7 March 2025

Our Ref: P222_481-1 (ACCESS DA) DV

**ACCESSIBILITY CAPABILITY STATEMENT FOR SSDA SUBMISSION
PROJECT NAME: 3-5 HELP STREET, CHATSWOOD**

Drawing No.
 SSSA-1101

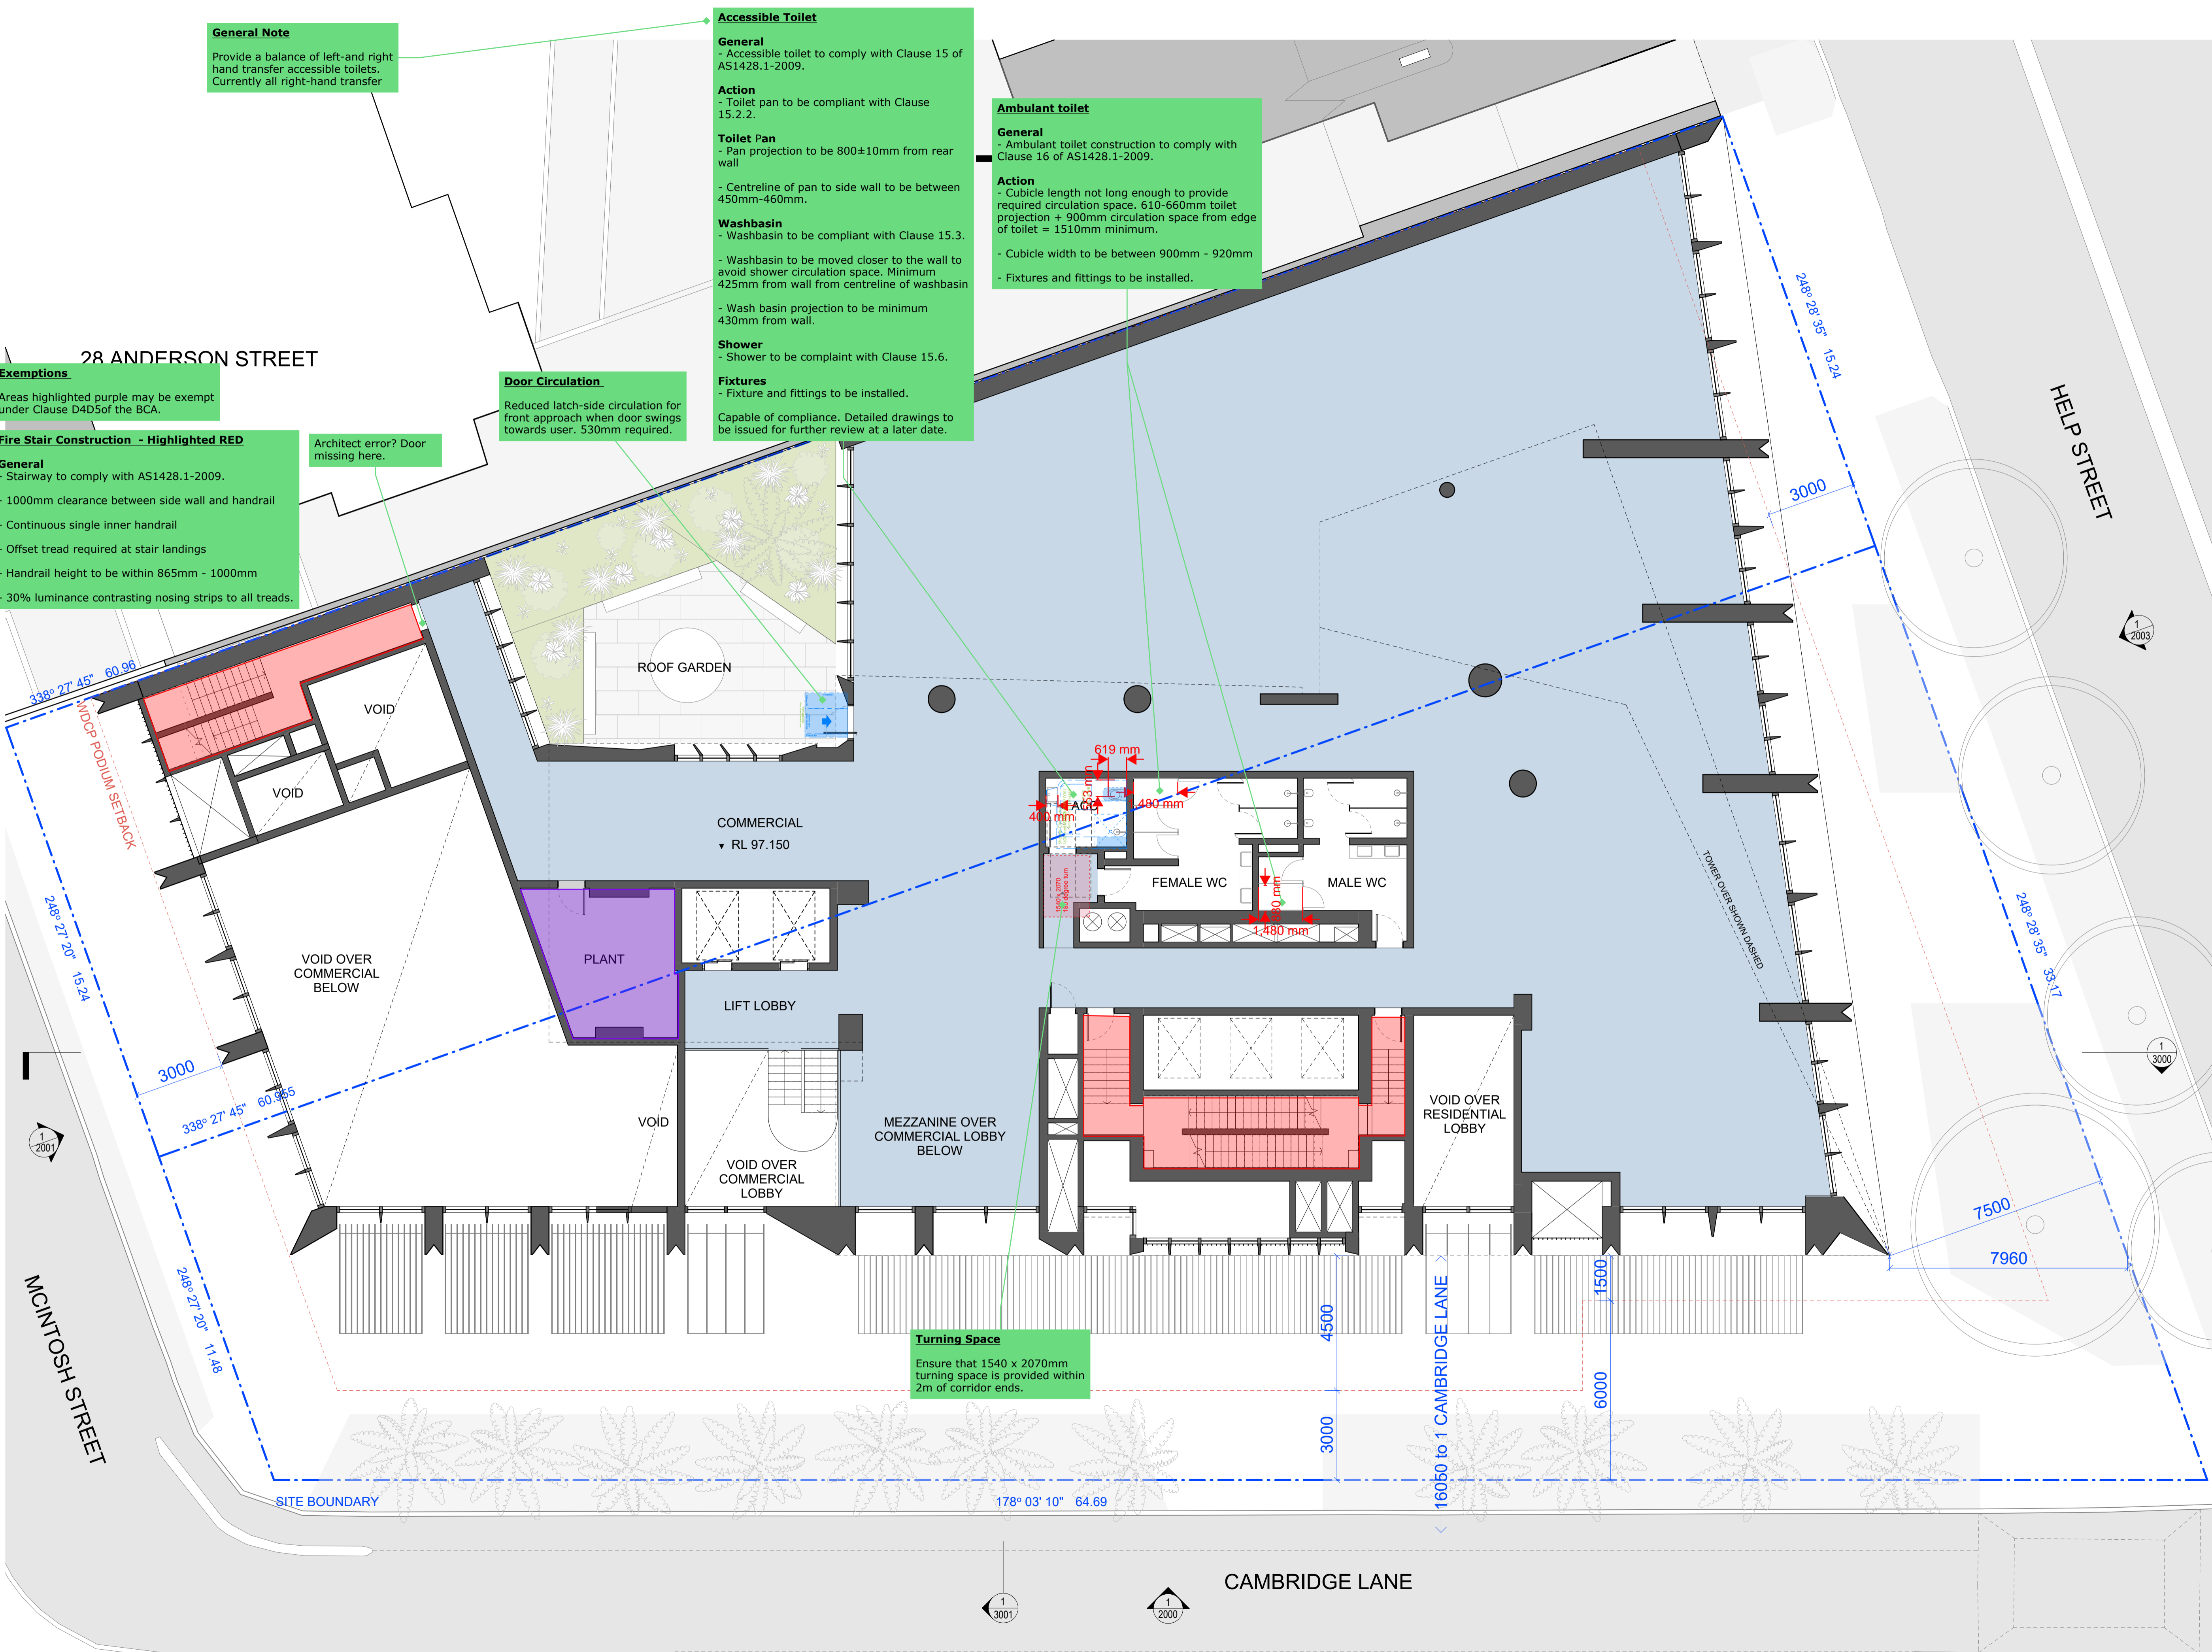
General Note
 Provide a balance of left-and-right hand transfer accessible toilets. Currently all right-hand transfer

Accessible Toilet
General
 - Accessible toilet to comply with Clause 15 of AS1428.1-2009.
Action
 - Toilet pan to be compliant with Clause 15.2.2.
Toilet Pan
 - Pan projection to be 800±10mm from rear wall
 - Centreline of pan to side wall to be between 450mm-460mm.
Washbasin
 - Washbasin to be compliant with Clause 15.3.
 - Washbasin to be moved closer to the wall to avoid shower circulation space. Minimum 425mm from wall from centreline of washbasin
 - Wash basin projection to be minimum 430mm from wall.
Shower
 - Shower to be compliant with Clause 15.6.
Fixtures
 - Fixture and fittings to be installed.
 Capable of compliance. Detailed drawings to be issued for further review at a later date.

Ambulant toilet
General
 - Ambulant toilet construction to comply with Clause 16 of AS1428.1-2009.
Action
 - Cubicle length not long enough to provide required circulation space. 610-660mm toilet projection + 900mm circulation space from edge of toilet = 1510mm minimum.
 - Cubicle width to be between 900mm - 920mm
 - Fixtures and fittings to be installed.

Door Circulation
 Reduced latch-side circulation for front approach when door swings towards user. 530mm required.

Architect error? Door missing here.

Turning Space
 Ensure that 1540 x 2070mm turning space is provided within 2m of corridor ends.

Drawing No.
 SSSA-1102

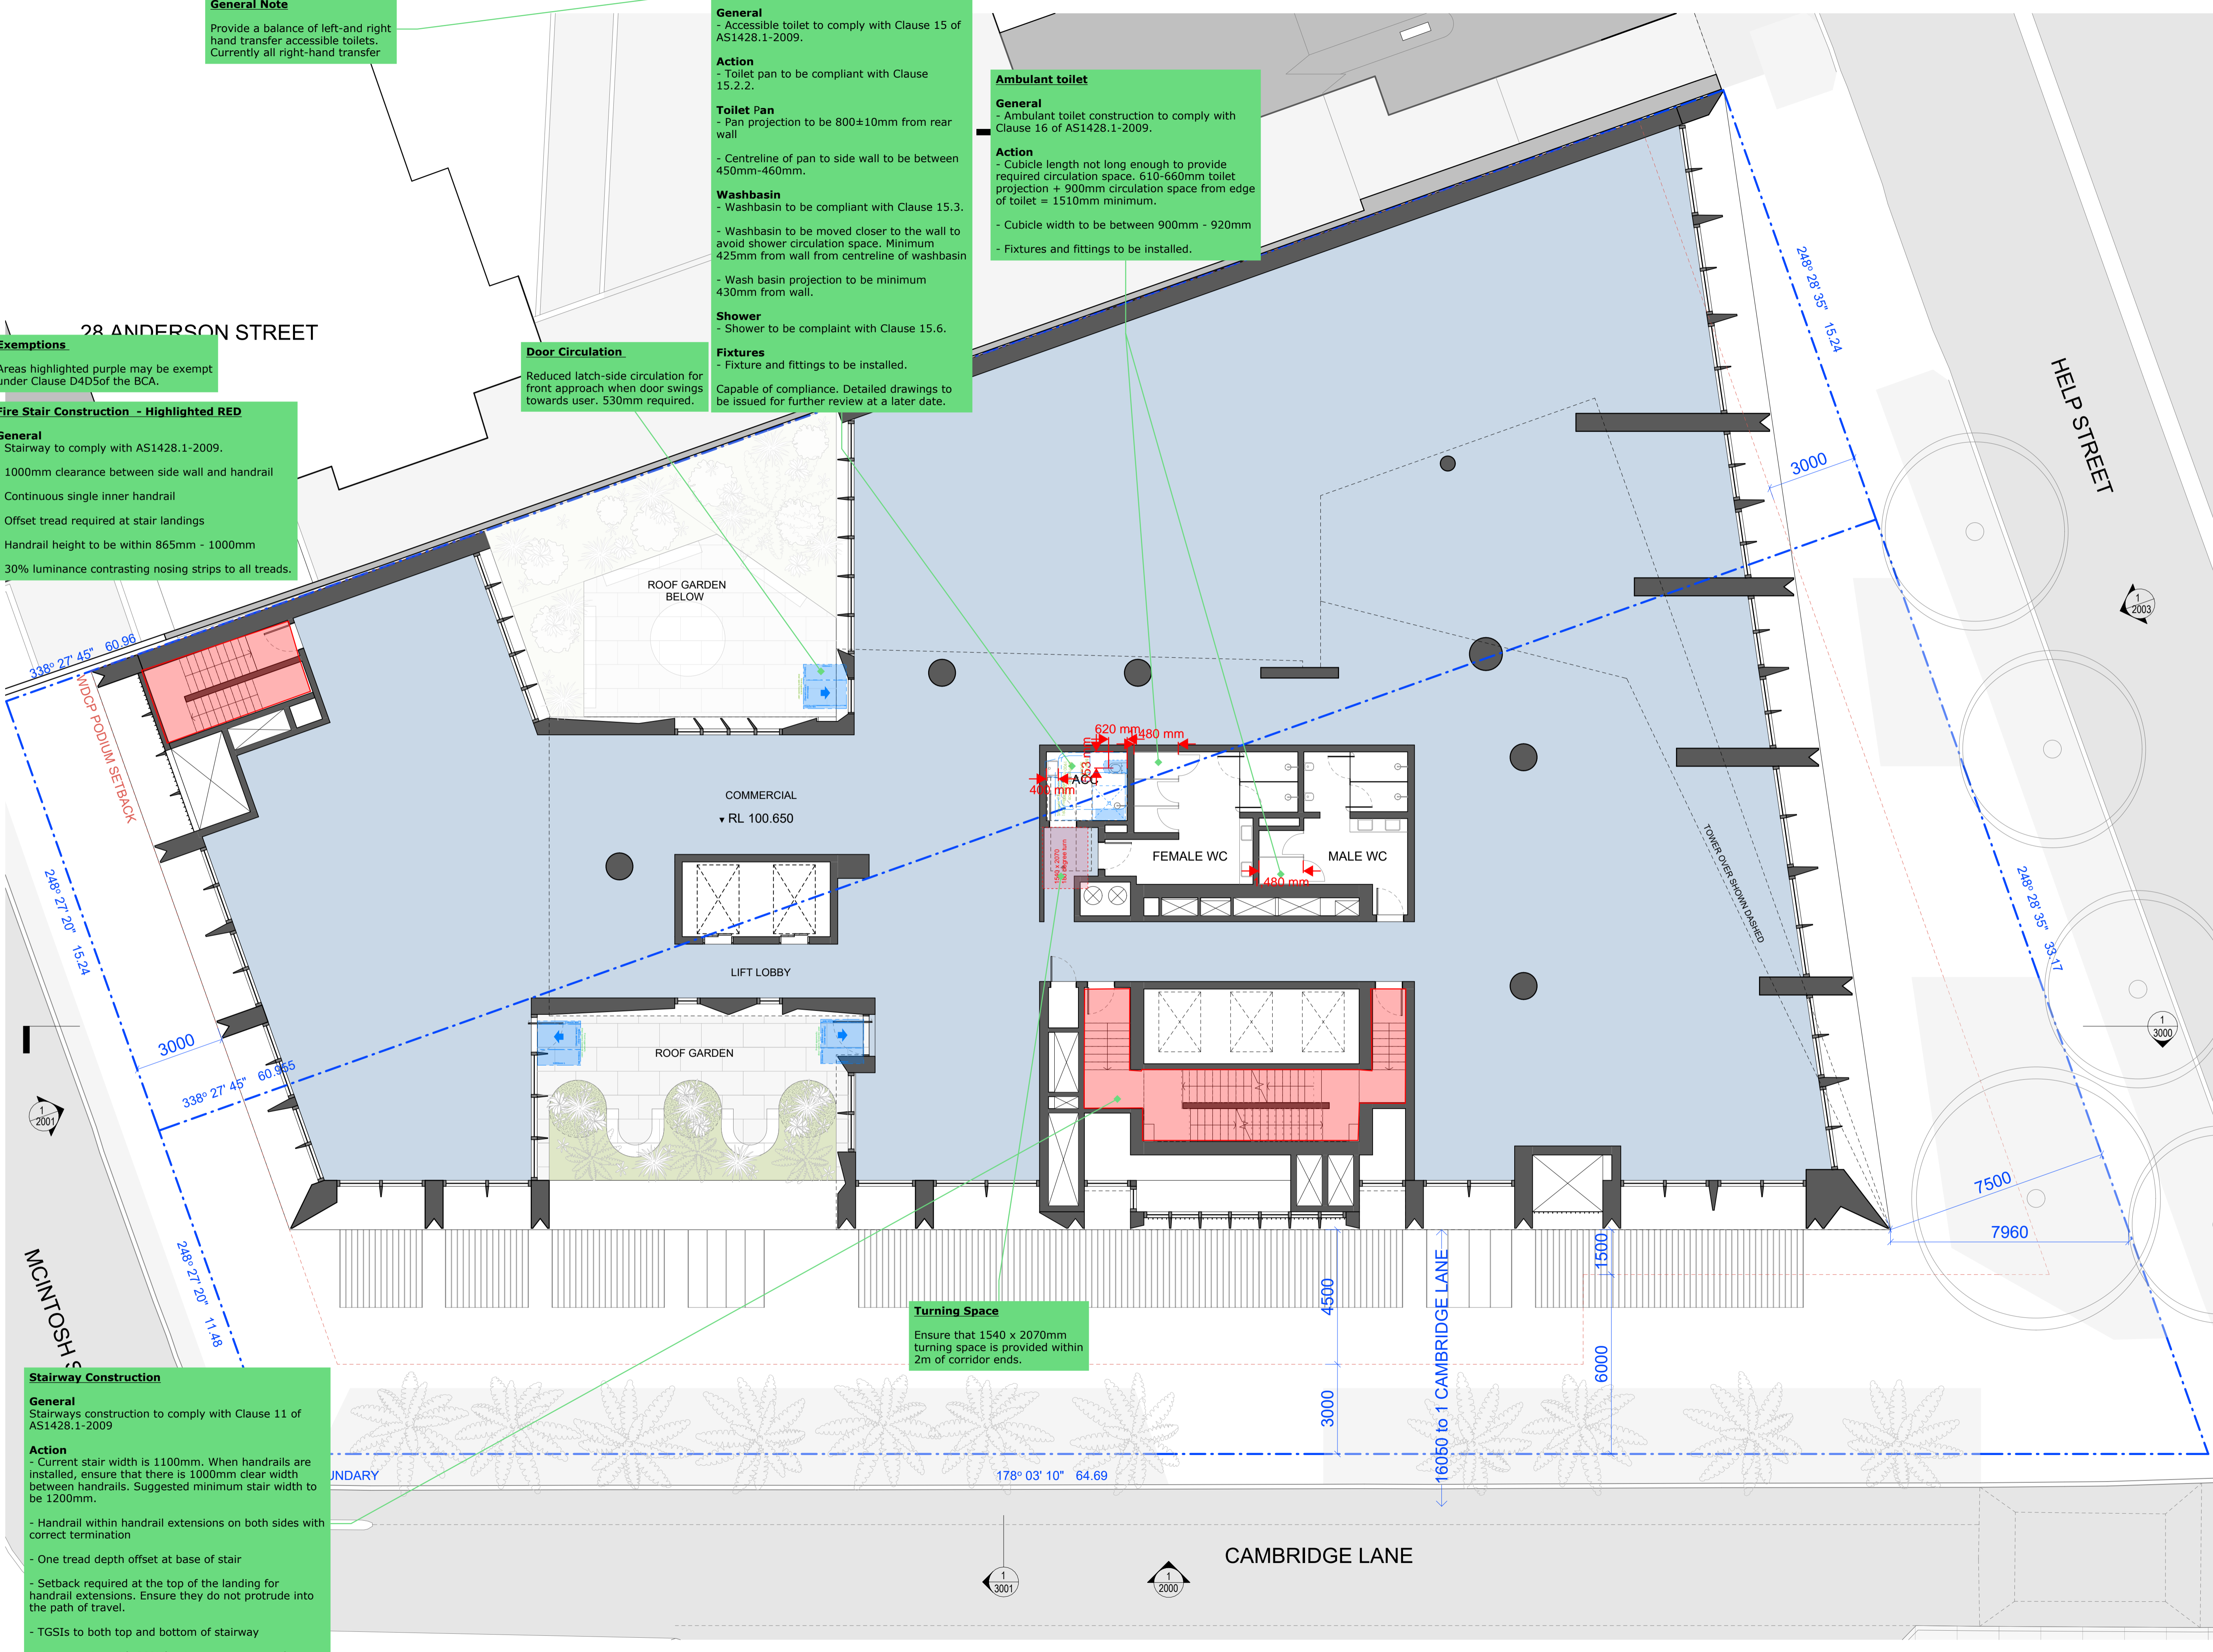
General Note
 Provide a balance of left-and right hand transfer accessible toilets. Currently all right-hand transfer

Accessible Toilet
General
 - Accessible toilet to comply with Clause 15 of AS1428.1-2009.
Action
 - Toilet pan to be compliant with Clause 15.2.2.
Toilet Pan
 - Pan projection to be 800±10mm from rear wall
 - Centreline of pan to side wall to be between 450mm-460mm.
Washbasin
 - Washbasin to be compliant with Clause 15.3.
 - Washbasin to be moved closer to the wall to avoid shower circulation space. Minimum 425mm from wall from centreline of washbasin
 - Wash basin projection to be minimum 430mm from wall.
Shower
 - Shower to be compliant with Clause 15.6.
Fixtures
 - Fixture and fittings to be installed.
 Capable of compliance. Detailed drawings to be issued for further review at a later date.

Ambulant toilet
General
 - Ambulant toilet construction to comply with Clause 16 of AS1428.1-2009.
Action
 - Cubicle length not long enough to provide required circulation space. 610-660mm toilet projection + 900mm circulation space from edge of toilet = 1510mm minimum.
 - Cubicle width to be between 900mm - 920mm
 - Fixtures and fittings to be installed.

Door Circulation
 Reduced latch-side circulation for front approach when door swings towards user. 530mm required.

Turning Space
 Ensure that 1540 x 2070mm turning space is provided within 2m of corridor ends.

Stairway Construction
General
 - Stairways construction to comply with Clause 11 of AS1428.1-2009
Action
 - Current stair width is 1100mm. When handrails are installed, ensure that there is 1000mm clear width between handrails. Suggested minimum stair width to be 1200mm.
 - Handrail within handrail extensions on both sides with correct termination
 - One tread depth offset at base of stair
 - Setback required at the top of the landing for handrail extensions. Ensure they do not protrude into the path of travel.
 - TGSIs to both top and bottom of stairway
 - Nosing strips with 30% luminance contrast to be provided to all treads.
